UNITED STATES ENVIRONMENTAL PROTECTION AGENCY

Subject: Transmittal of "Port of Stockton Municipal Separate Storm Sewer Audit Report"

Port of Stockton Municipal Separate Storm Sewer System (MS4) Audit Report

Exhibit 1 – Approximate location of the Daggett Road Project Packages A, B, C, D, and E (adapted from the SWPPP for Navy Drive to McCloy Security Reroute Project Package D, dated April 13, 2007).

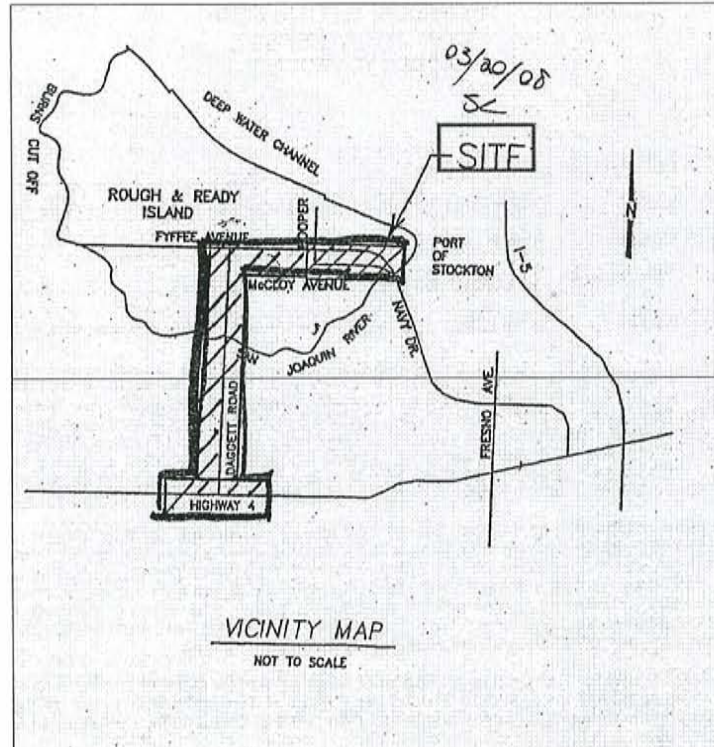
This site was a Port-owned and -administered roadway construction and improvement project along a linear length of roadway from State Route 4 to the Navy Drive Bridge spanning the San Joaquin River. The project consisted of new roadway construction, rerouting, and widening, in addition to the construction of the Port of Stockton Expressway Bridge, a new bridge spanning Burns Cutoff. The project was developed in a series of phases or “packages” under a common plan of development over time. Packages A, B, C, D, and E are within a contiguous area connected by Daggett Road, McCloy Avenue, and Fyffe Avenue (Exhibit 1). Based on Notice to Proceed documents issued by the Port, Packages B, C, D, and E were approved and constructed after the February 17, 2006, DSP compliance date (Exhibit 2, for example). It is unclear why the Port failed to identify the Daggett Road Project as a DSP project when the A-Plus tenant site triggered the DSP requirements based on the addition of impervious surfaces over time and will likely be required to implement treatment control BMPs in accordance with the DSP (Exhibit 3).

Because of the likelihood that additional projects qualify as Priority Development Projects, the Port must review all completed projects initiated since the Order effective date (October 15, 2004), as well as all current and proposed construction and development projects, for DSP applicability. The Port must develop a list of these projects, including all data necessary to determine whether the projects qualify as Priority Development Projects. The required data include but are not limited to project description at build-out, land use, impervious land area for development (square feet), area of impervious surface created or replaced (square feet), Standard Industrial Classification (SIC) code, number of parking spaces, and all other data relating to the Priority Development Project Categories specified in Section C.14 of the Order. As a component of the list, the Port must make an initial Priority Development Project Category determination regarding the need for DSP conditioning and supporting rationale.

Photograph 2: BMPs were not implemented between the slope and the adjacent drainage channel or in the disturbed drainage channel itself, and the surface of the slope was not stabilized.

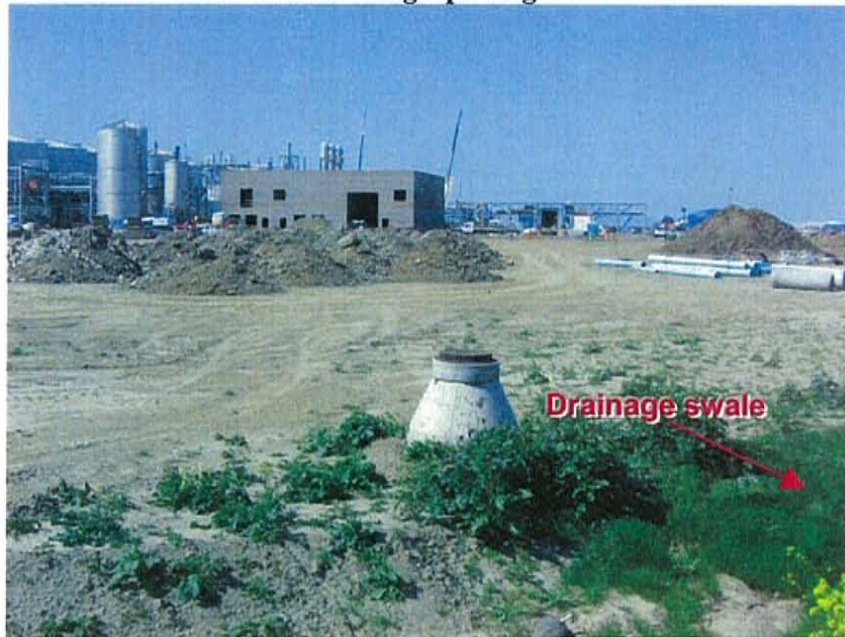
Section C.7.a.ii of the Order requires that Port inspections of construction sites ensure that sediments generated at a project site are retained on-site and that erosion from slopes and channels is controlled by implementing an effective combination of erosion and sediment control BMPs. It was observed during the audit that BMPs were not implemented to prevent the discharge of sediment from an actively disturbed slope adjacent to a drainage channel along Navy Drive and southeast of the construction site entrance (Photograph 1). BMPs were not implemented between the slope and the adjacent drainage channel or in the disturbed drainage channel itself, and the surfaces of the slope and channel were not stabilized (Photograph 2). As a result, there was a potential for the discharge of sediment from the disturbed slope and drainage channel leading to the South Ditch and East Complex Retention Basin. In addition, BMPs had not been implemented between a large expanse of disturbed soils, a number of uncontrolled soil stockpiles, and the adjacent drainage swale (Photographs 3 and 4). Evidence of erosion, including rill formation on the slope of the drainage swale (Photograph 4), was observed. The Port Construction Site Inspector explained that the drainage swale that encompasses the site discharges through a storm drain outfall into the drainage channel along Navy Drive (Photograph 5), leading to the South Ditch, East Complex Retention Basin, and ultimately the San Joaquin River. BMPs must be installed, inspected, and maintained to prevent the discharge of sediment from the aforementioned disturbed areas of the site to the drainage channel along Navy Drive. Moreover, the Port must ensure that

sediments generated at the Pacific Ethanol project site are retained on-site and that erosion from slopes and channels is controlled by implementing an effective combination of erosion and sediment control BMPs.

Photograph 5: Pacific Ethanol storm drain outfall into the drainage channel along Navy Drive.

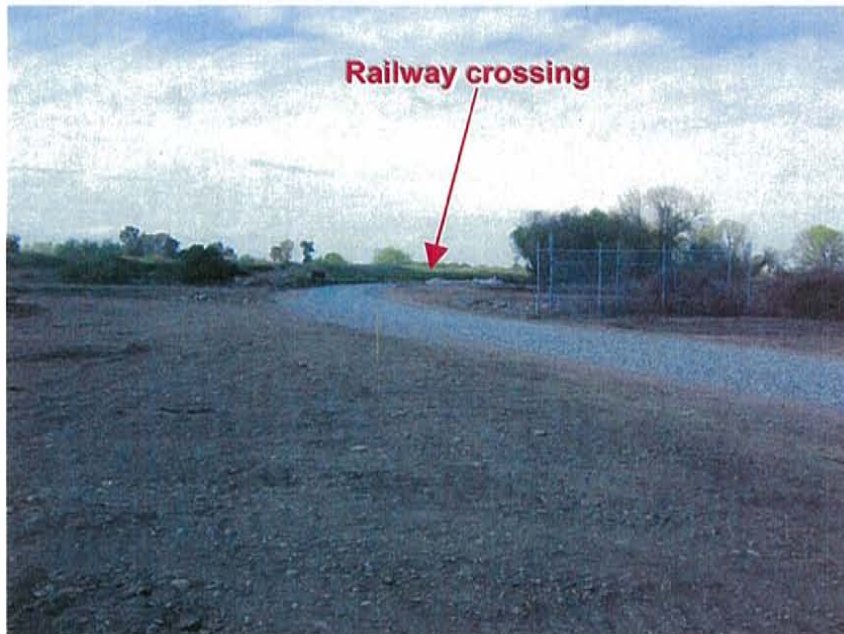
Photograph 3: BMPs were not implemented between a large expanse of disturbed soils, a number of uncontrolled soil stockpiles, and the adjacent drainage swale.

Photograph 4: Evidence of erosion was observed; including rill formation on the slope of the drainage swale.

Photograph 11: View of Lowe's Distribution Center equipment maintenance shop.

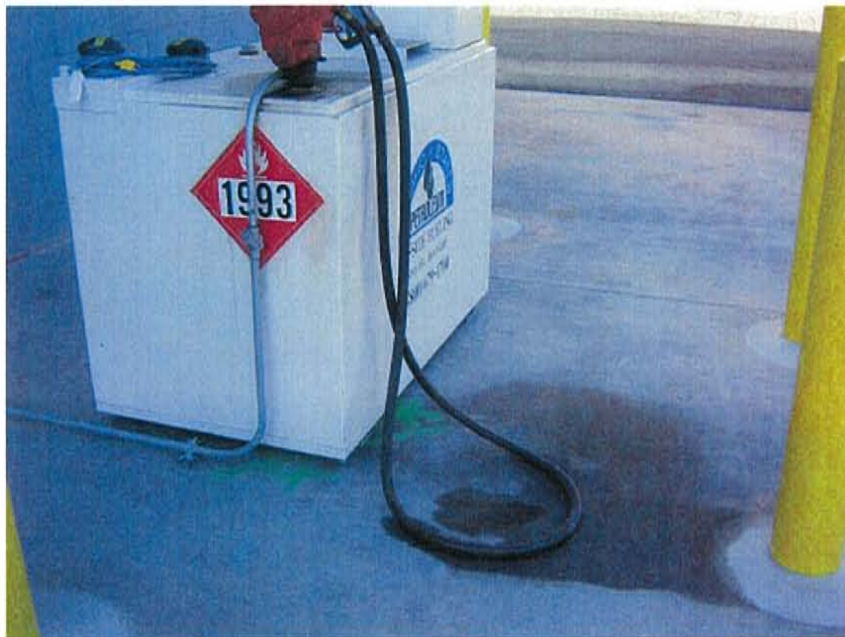
The Lowe’s Distribution Center is a completed commercial project consisting of a warehousing and distribution facility for home improvement goods and building and construction materials. Section C.14.a.v of the Order defines the parking lot category as “parking lots exposed to rainfall that are 5,000 square feet or more, or with 25 or more parking spaces.” The site includes a newly constructed equipment maintenance (Photograph 11) and fueling (Photograph 12) shop and approximately 20 acres of

Photograph 12: View of Lowe's Distribution Center fuel storage tank located adjacent to the maintenance shop.

impervious parking improvements (Photographs 13 and 14). As a result, this project likely qualifies as a Priority Development Project under both the commercial and parking lot categories. Based on Port records provided during the audit, the Lowe's HIW, Inc., lease approval date (September 5, 2006) and construction start date occurred after the February 17, 2006, DSP compliance date (Exhibit 4) and therefore should have been reviewed and conditioned for compliance with the Development Standards.

Photograph 13: Impervious parking improvements at the Lowe's Distribution Center (looking north).

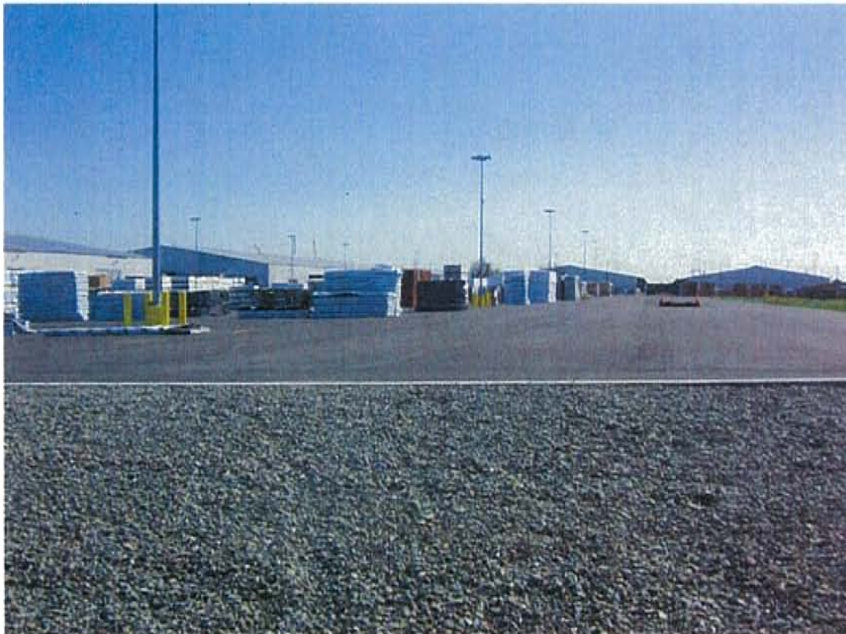
Photograph 14: Impervious parking improvements at the Lowe's Distribution Center (looking east).
